E-101 Simplified Electrical Layout - Hospital

Areas: emergency department, ICU, operating rooms, patient rooms, imaging area, and nurse stations

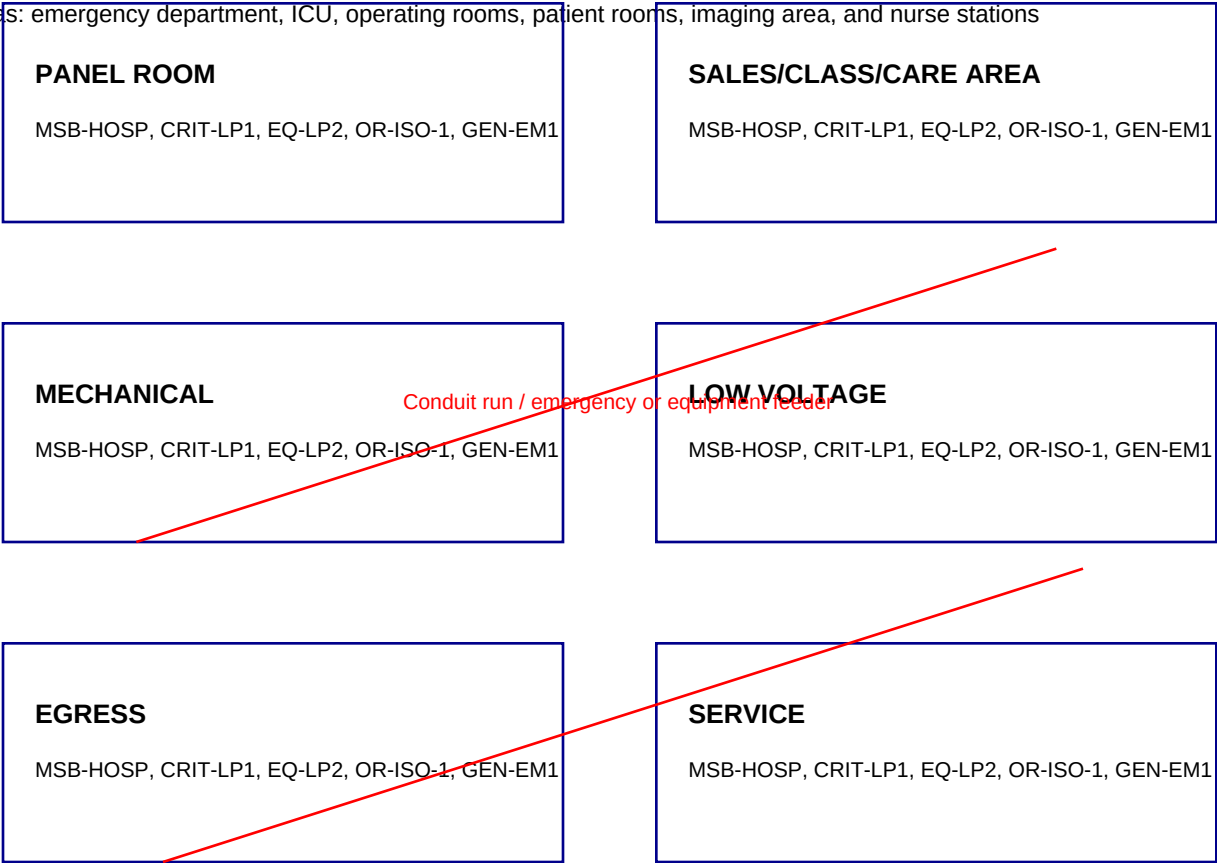
1. OR isolated power is supported by panel OR-ISO-1 with line isolation monitoring.
2. Generator GEN-EM1 backs emergency and critical circuits through ATS-1 and ATS-2.
3. The MRI requires a dedicated feeder from EQ-LP2 with isolated grounding requirements.
4. Change order CO-HOSP-004 adds backup power to the imaging wing including ATS tie-in and critica
5. Nurse call system emergency power is questioned in RFI-HOSP-033 and remains open pending owner
